April 6, 2012

Cogentrix Quail Brush Generation Project – Docket Number 11-AFC-3, Data Request Responses to Set 2

Transmission System Engineering

ATTACHMENT K
PRE- AND POST-PROJECT ELECTRICAL ONE-LINE DIAGRAM

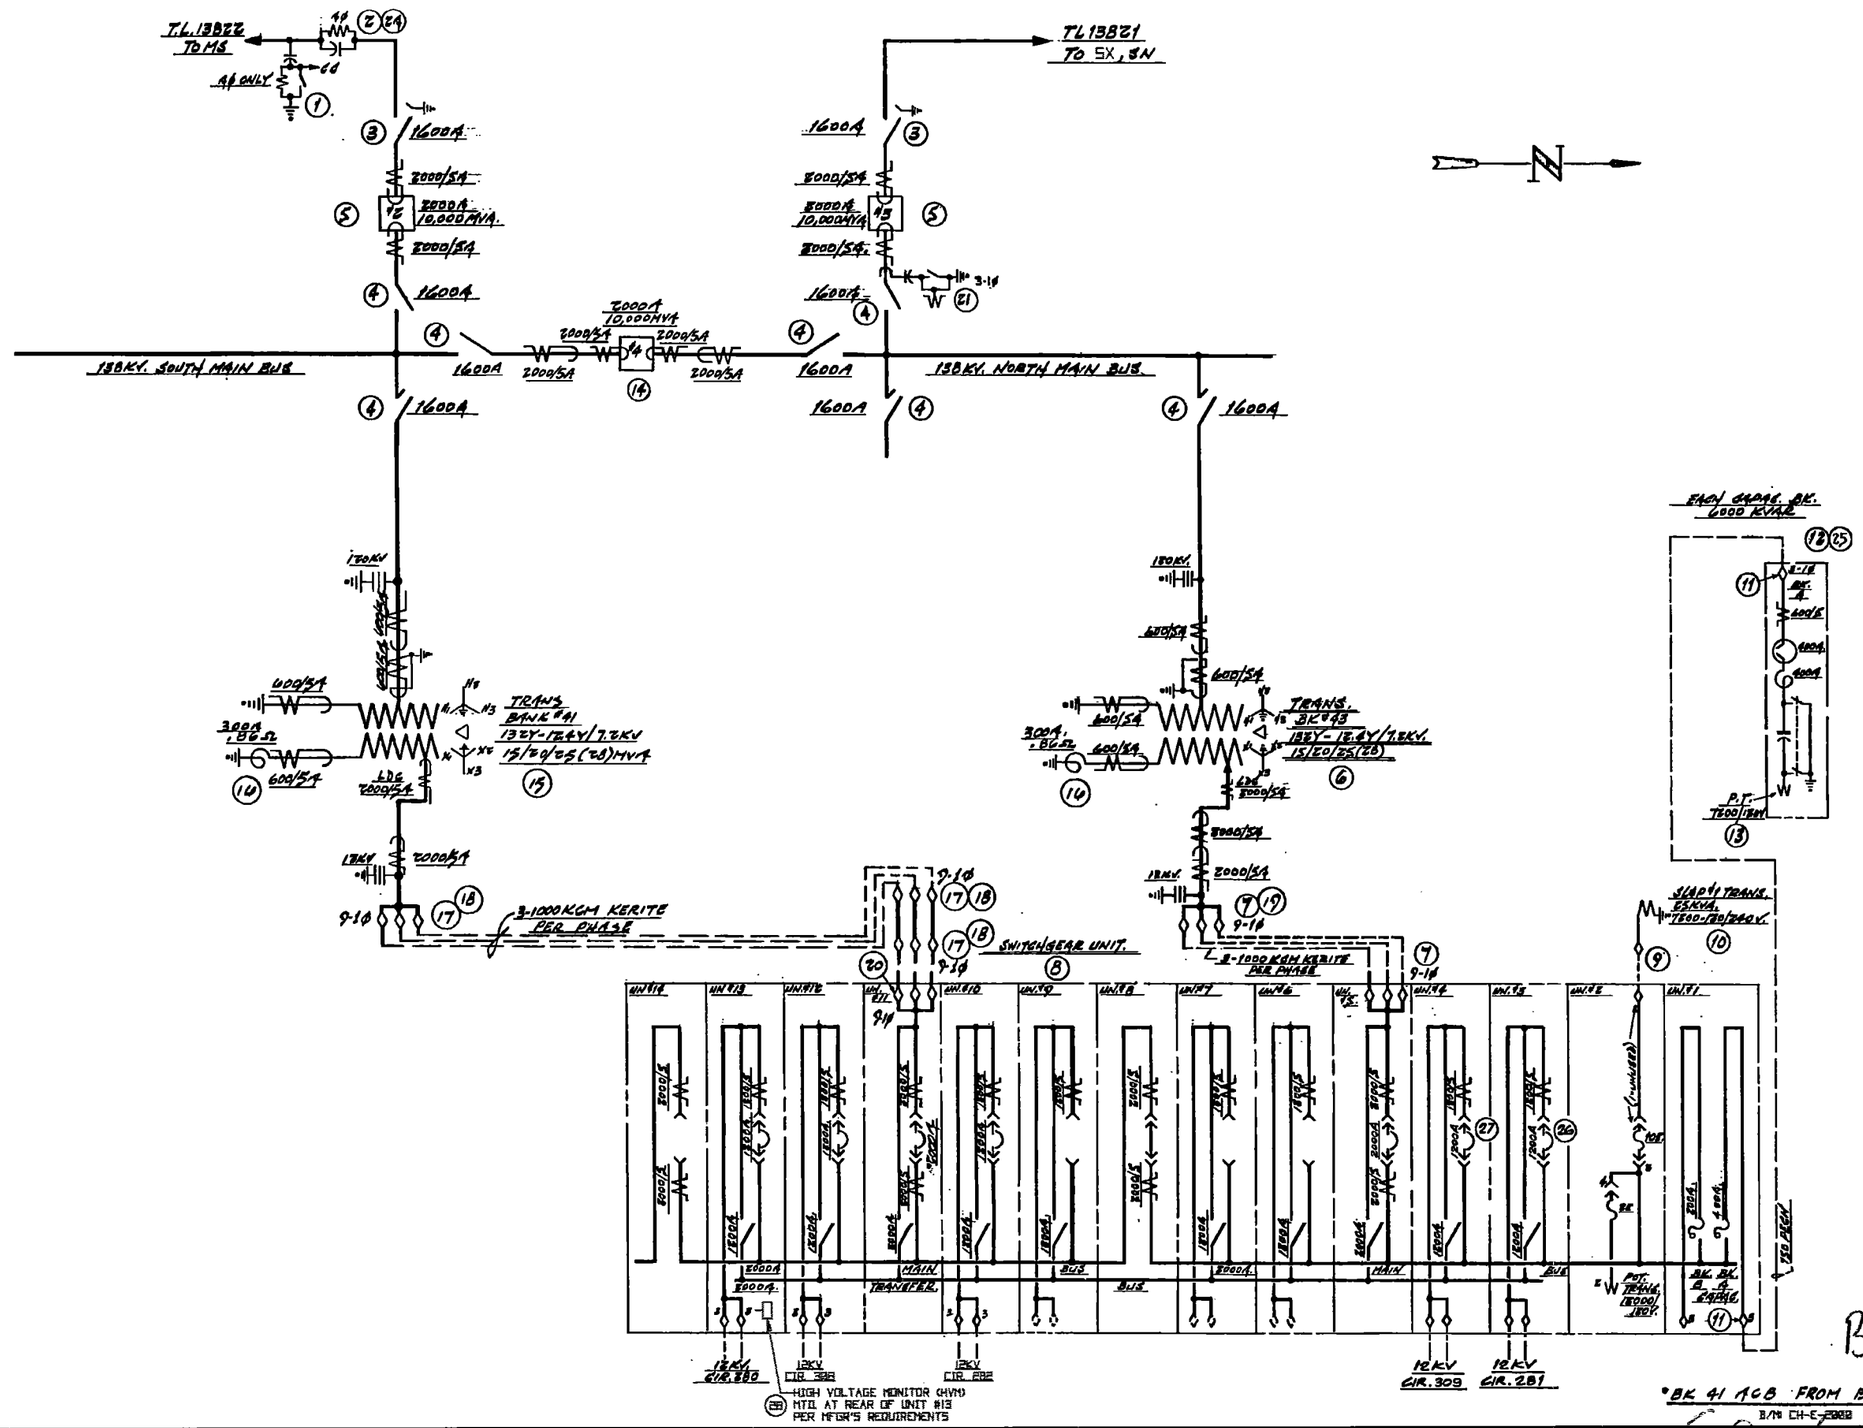
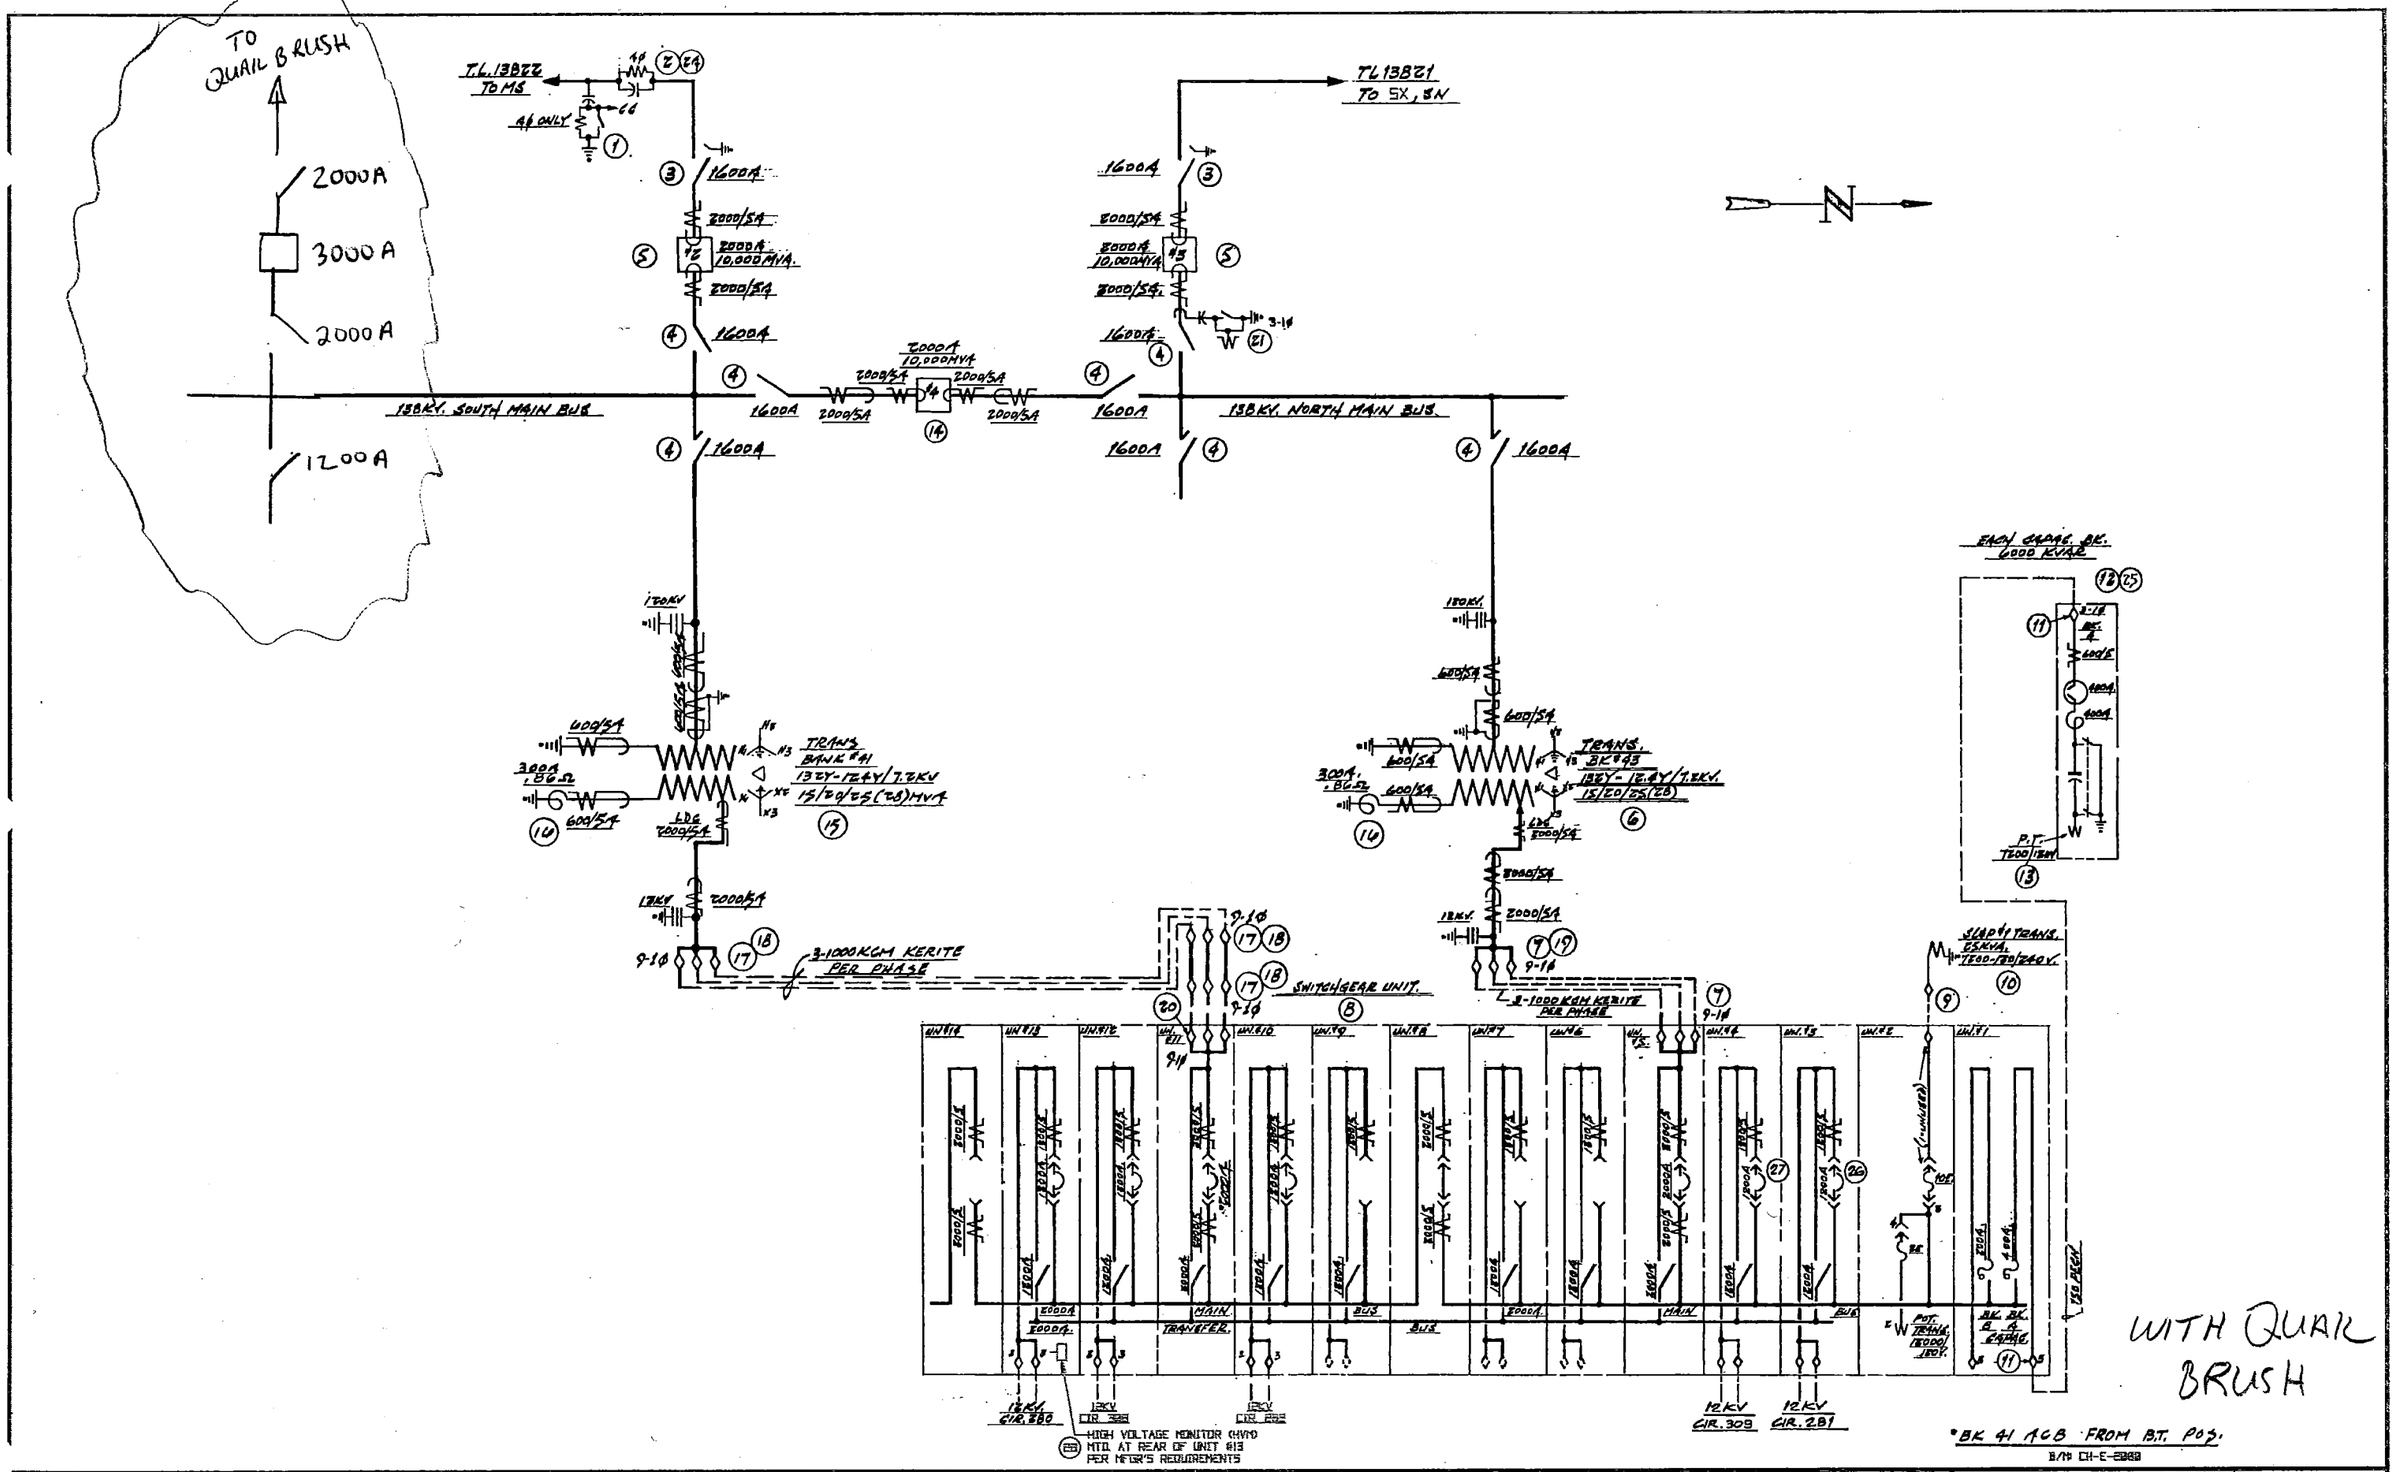
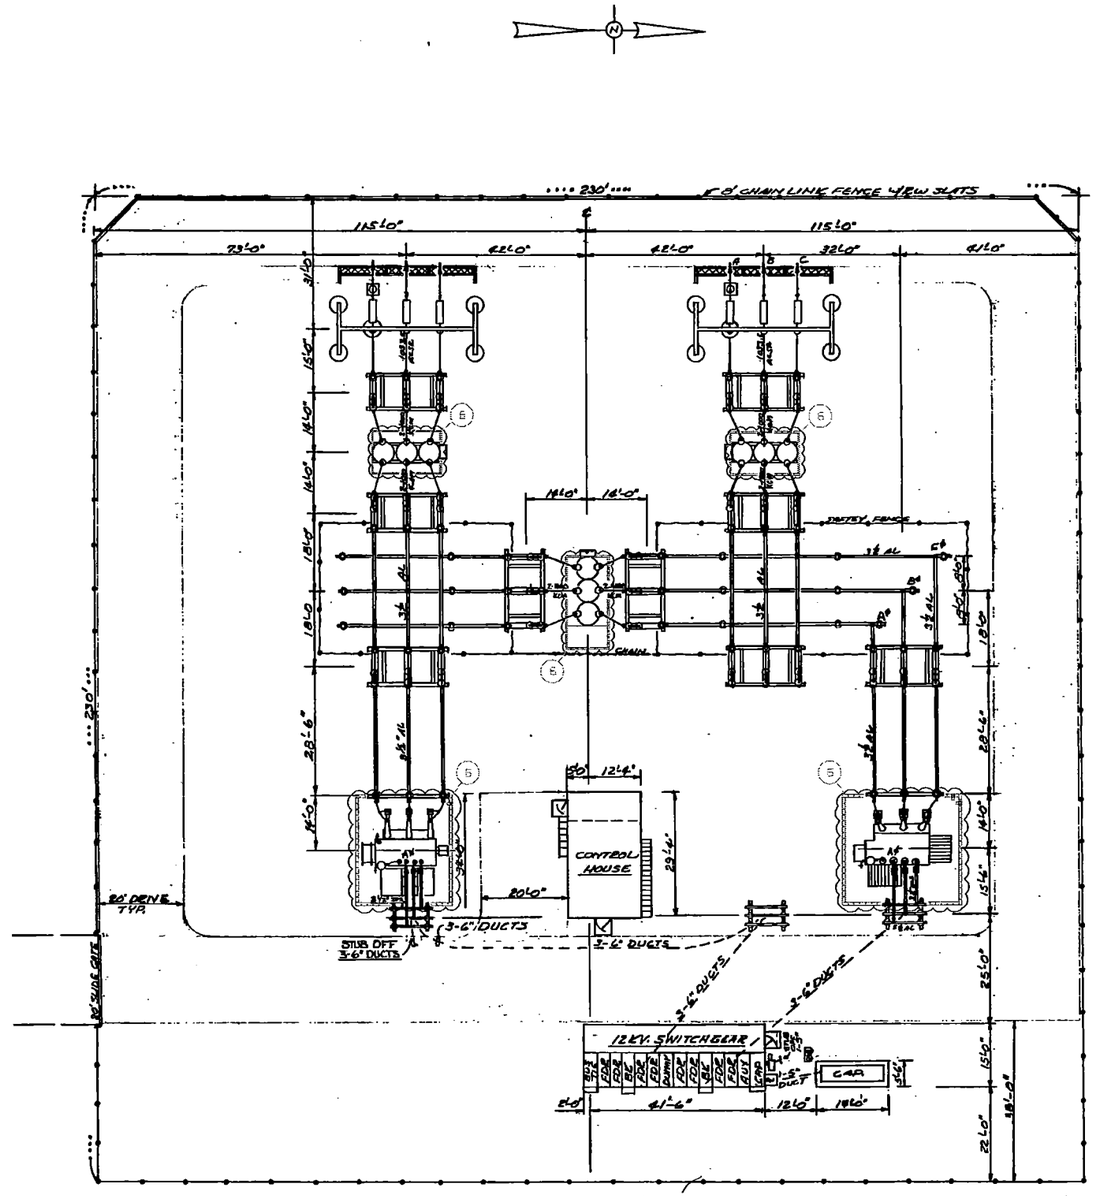
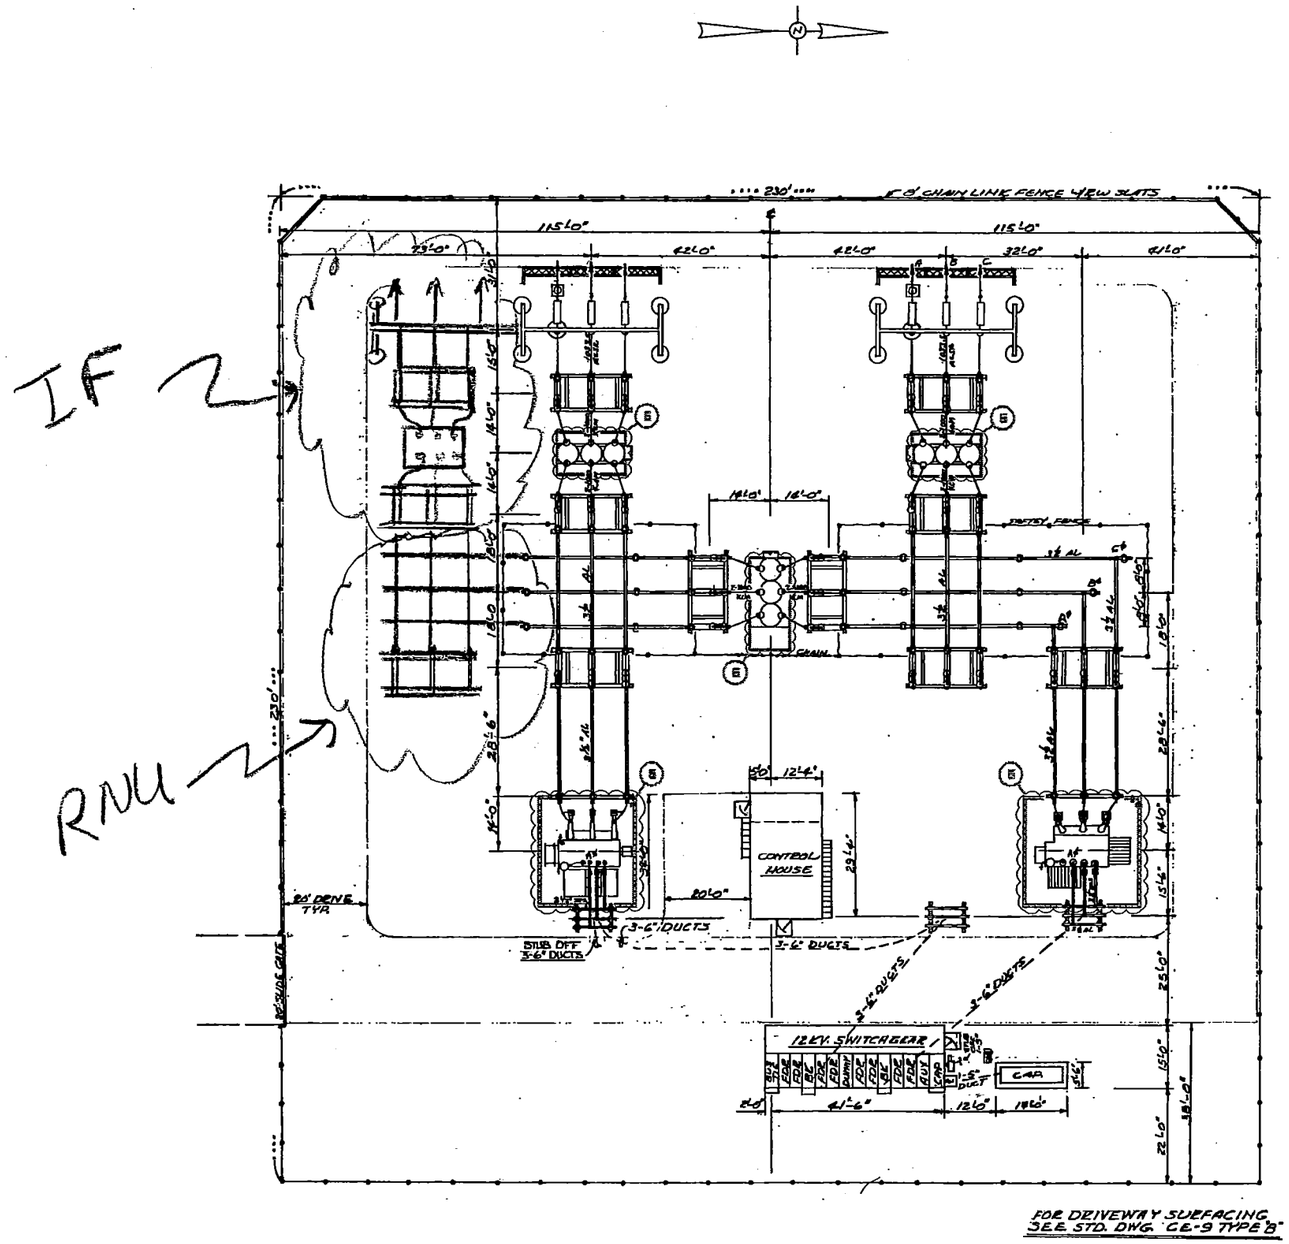
63. Please provide pre and post-project electrical one-line diagrams of the SDG&E Carlton Hills 138 kV substation with all transmission outlets showing the proposed modifications in the substation for interconnection of the gen tie line along with configuration of buses, breaker, disconnect switches, and their respective sizes and/or ratings.

The pre- and post-Project electrical one-line diagrams of the Carlton Hills 138 kV substation have been provided by SDG&E and are included as Attachment K. The post-Project drawings in Attachment K depict the Preferred route terminating in the empty south bay of the Carlton Hills Substation.
